Major Drainageway Infrastructure Alternatives - Walton Creek
Citywide Stormwater Master Plan
Steamboat Springs, Colorado

APPENDIX D –CORRESPONDENCE

Steamboat Springs Stormwater Master Plan

Notes:

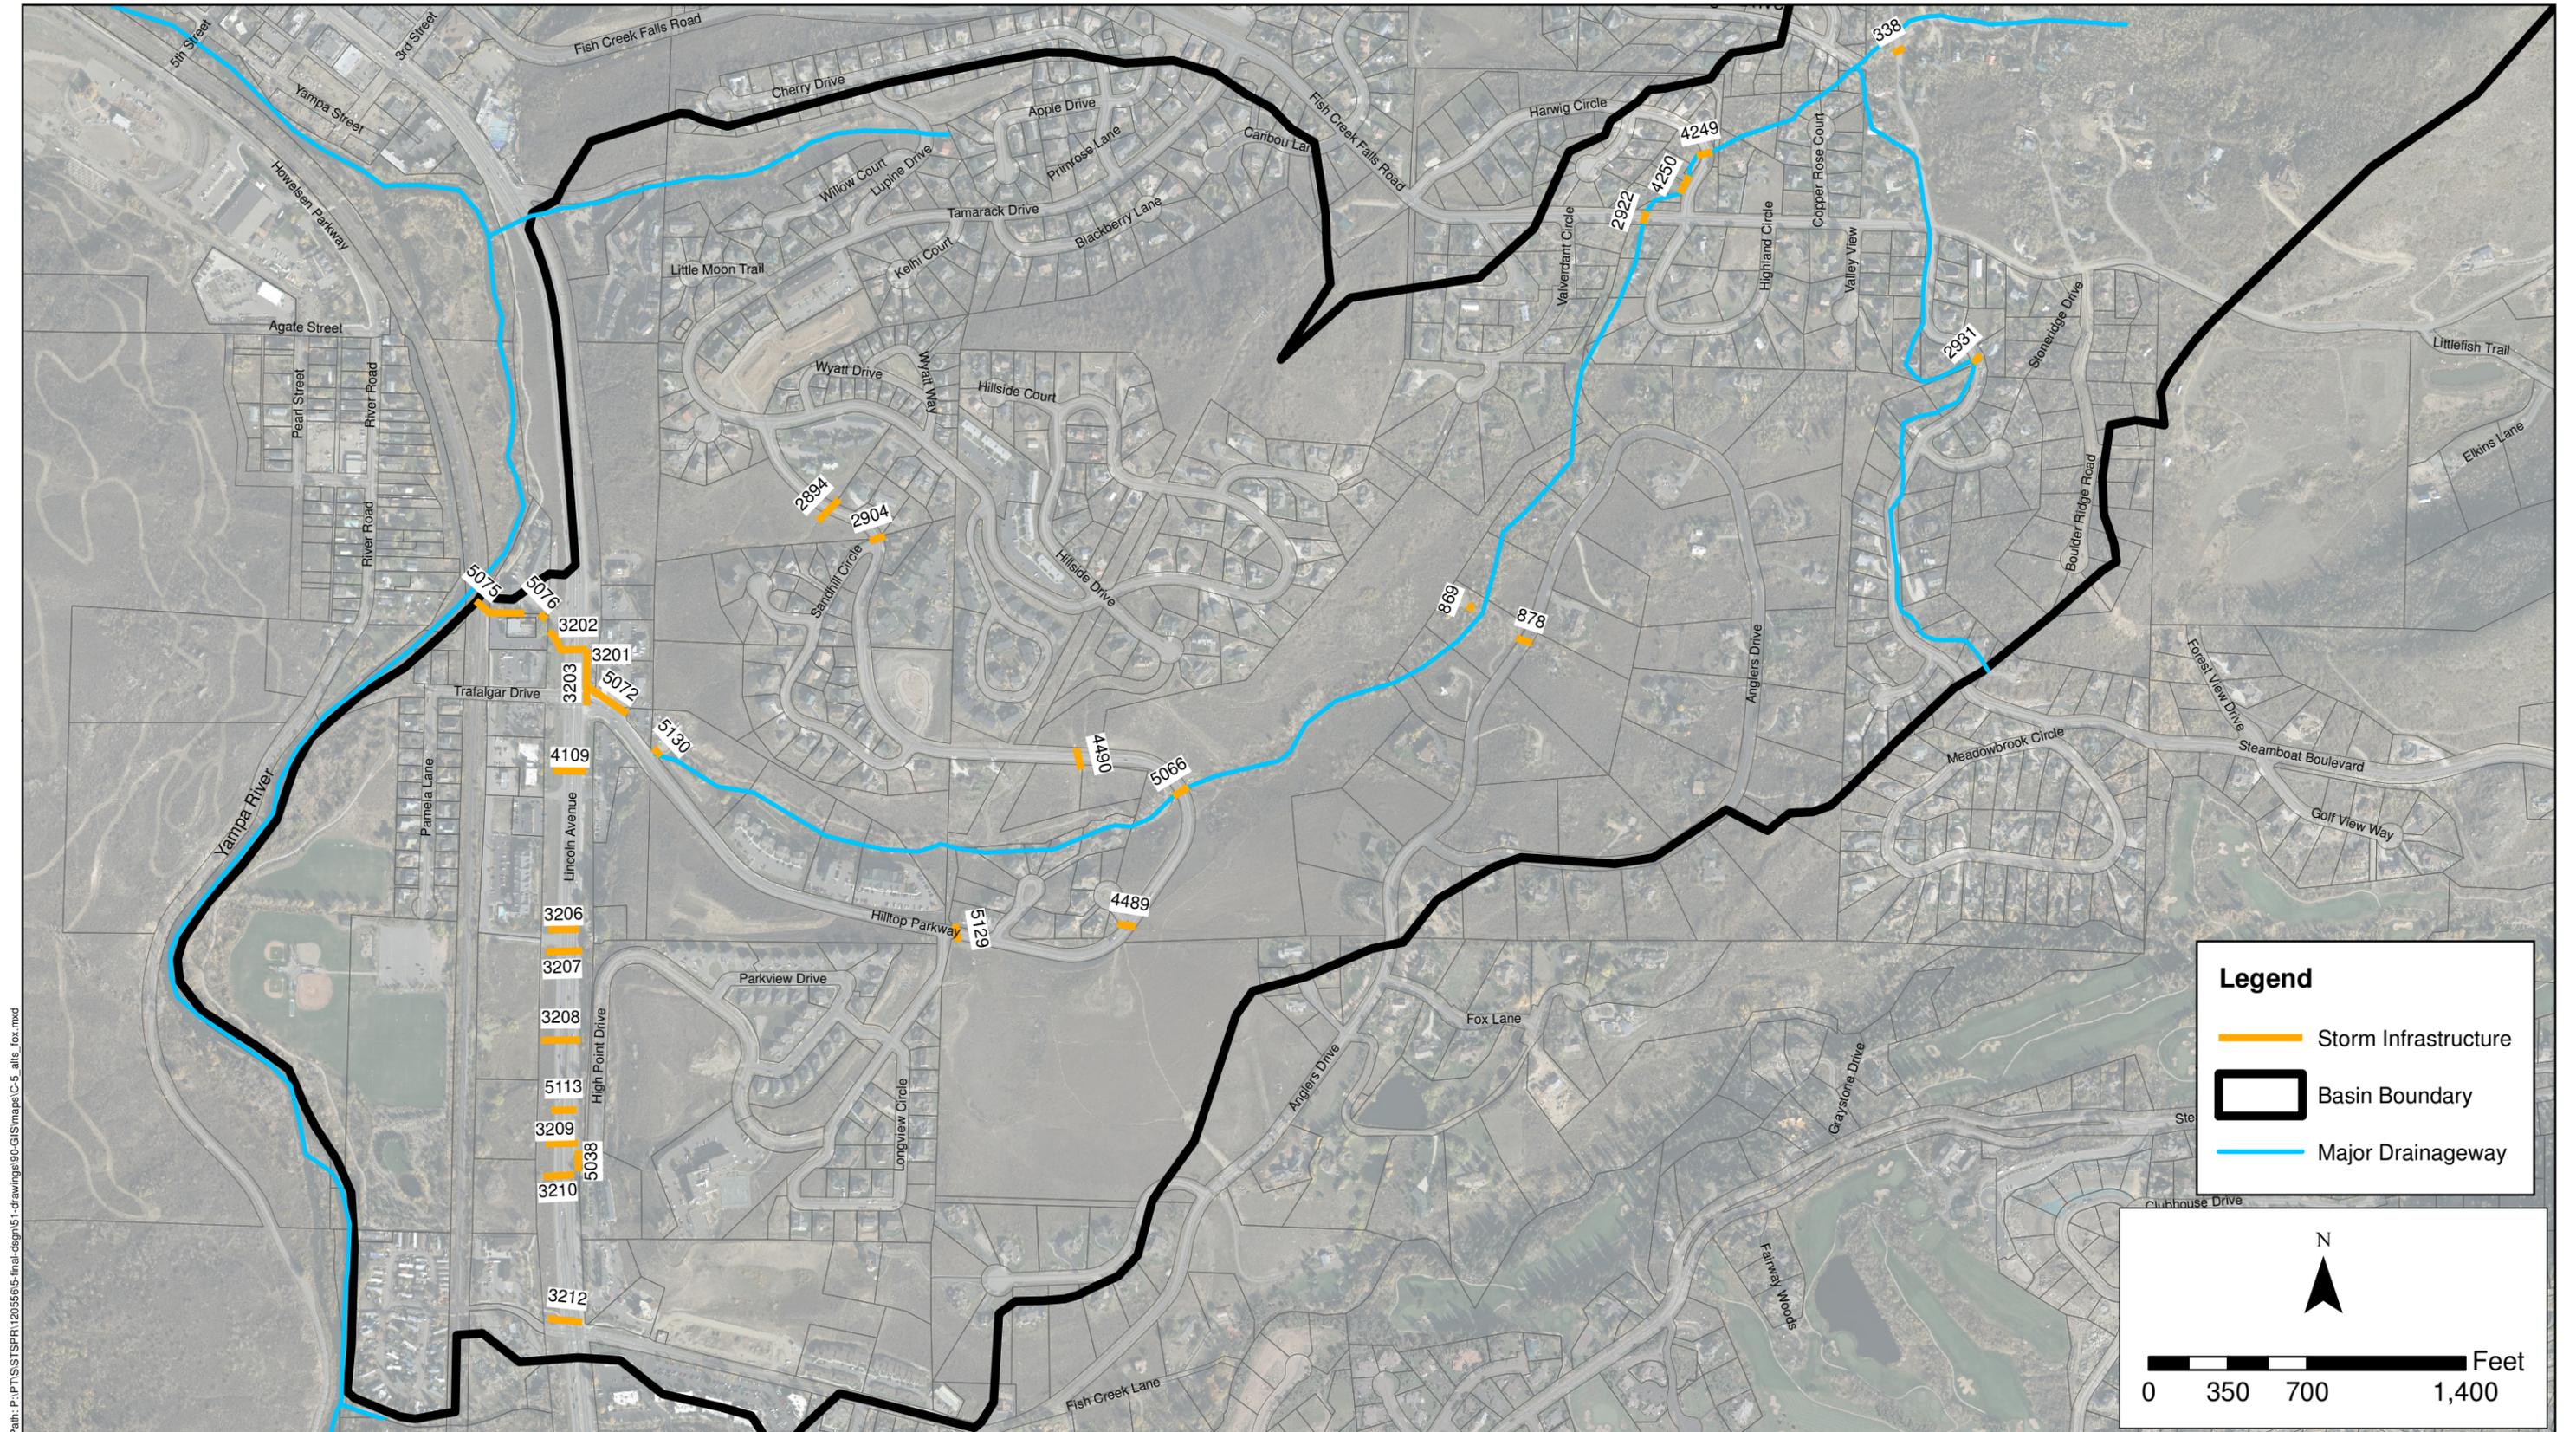
Ben Beall	Please add the culvert ID# as shown on the Problems and Needs Maps with the recommendations shown in the Alternatives Analysis in Appendix C.	The culvert ID# has been added to the spreadsheets in Appendix C for easier cross referencing.
Ben Beall	In 2.2.10, you describe EM/ORM as slightly larger than 2 acres. Is this a typo? Should it read "2 square miles?"	Yes, the EM/ORM basin is just over 2 square miles in size.
Ben Beall	You list in the Problems and Needs written section that the drainage at Skyview Lane should be addressed, yet there is no graphic representation of this on the Problems and Needs map. What needs to be done at this intersection? This location was specifically identified as a problem drainage location at the May 15th kickoff meeting. The required improvements and estimated cost should also be captured in Table C-1 when that is complete and the reference numbers are included. In Table C-1 you show that there are 3 36" existing CMP. There are only 2 that cross under Whistler, plus a third smaller culvert.	The east roadside swale/ditch for Whistler Road does not have sufficient capacity to convey flows, and backs up onto the street. Twin 36-inch CMPs carry flow beneath Whistler Road to the north roadside swale/ditch for Skyview Lane. The 3rd, smaller culvert is non-functional according to City staff. Redevelopment of the northwest corner of this intersection includes a proposal to convey part of the flows to the south roadside swale/ditch of Skyview Lane.

Ben Beall	It does not appear that the recommendations on the Problems and Needs Map match the recommendations on the Alternatives Analysis. For example, for Burgess Creek at Stonecreek Court on the P/N map, you show clearing the culvert to restore capacity (#25 and #26) and in the Alternatives Analysis you show replacing with a 66" RCP (#1336). That means that we are assigning a replacement cost to the overall numbers when you are recommending immediate maintenance only elsewhere. It appears that the alternative analysis sizes ALL culverts to convey the 100-year flow. The City Drainage Criteria does not require this of all culverts. It requires 100yr capacity for all collector and arterial roads and 5yr capacity for all others. We discussed this at length in progress meetings. Why are you including costs to replace culverts that meet current City Drainage criteria?	We recommend clearing culverts to restore capacity in every case where we observed clogged culverts in the field. Clearing clogged culverts optimizes the existing stormwater conveyance system. The existing culvert at Stonecreek Court at Burgess Creek needs to be replaced to convey the 100-year storm event. We used the 100-year storm event because the 100-year event is an engineering standard, and to be conservative for stormwater funding purposes. Because this is a conceptual-level report for stormwater funding purposes, we agreed to use the 100-year storm event for modeling purposes. When more detailed outfall systems planning studies are performed on a basin-by-basin basis, more scrutiny can be applied to individual issues, problems, and needs.
